City of Portland, Maine – Building or Use Permit Application 389 Congress Street, 04101, Tel: (207) 874-8703, FAX: 874-8716

RE: Certificate of Occupancy
64 Copley Woods Circle (lot 18)

DATE: 8/1/99 ADDRESS: 64 Copley Woods Circle (lot #18) CBL 413-B-018
 REASON FOR PERMIT: Single Family dwelling/attached garage.
 BUILDING OWNER: KTO Builders
 PERMIT APPLICANT: SAA
 USE GROUP R-3 BOCA 1996 CONSTRUCTION TYPE 5B

KTO BUILDERS
 COPLEY WOODS LOT# 18
 SCALE 1" = 20'

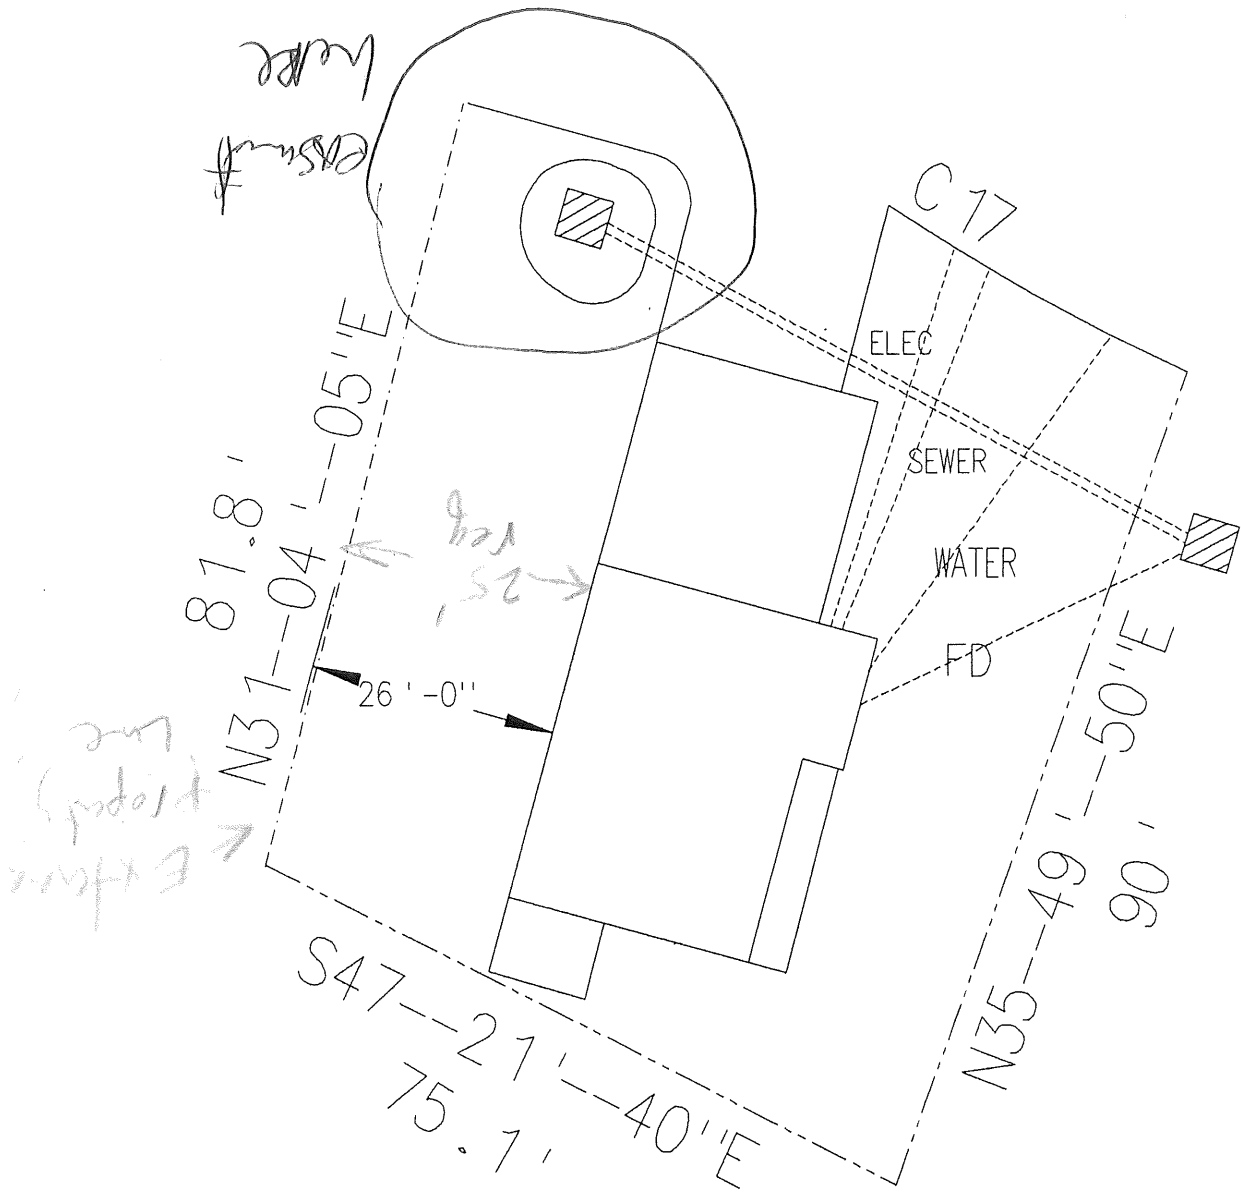
1. The street number needs to be placed on the house.
2. Final grading exceeded the property line to the rear and into the common open space and into the wetlands associated with this area. The applicant has indicated that they will restore the wetland area by planting two to three 2-1/2" caliper native wetland type trees 5' to 6' off the property line in the wetland/common open space area and seed the wetland area with a wetland type seed mix. Please find attached correspondence from KTO Builders on this issue.

As we discussed this morning I will be planting two to three 2 1/2" caliper native trees 5 to 6 feet off the property line in the wet land area off of lot 18 as well as seeding the area with a wetland grass seed. I will also be stabilizing the bank in front of the house. I will consider the matter taken care of at the time of completion and assume that you do not have any other issues with the grading and landscaping of the lot other than what is shown on the landscaping plan for the lot.
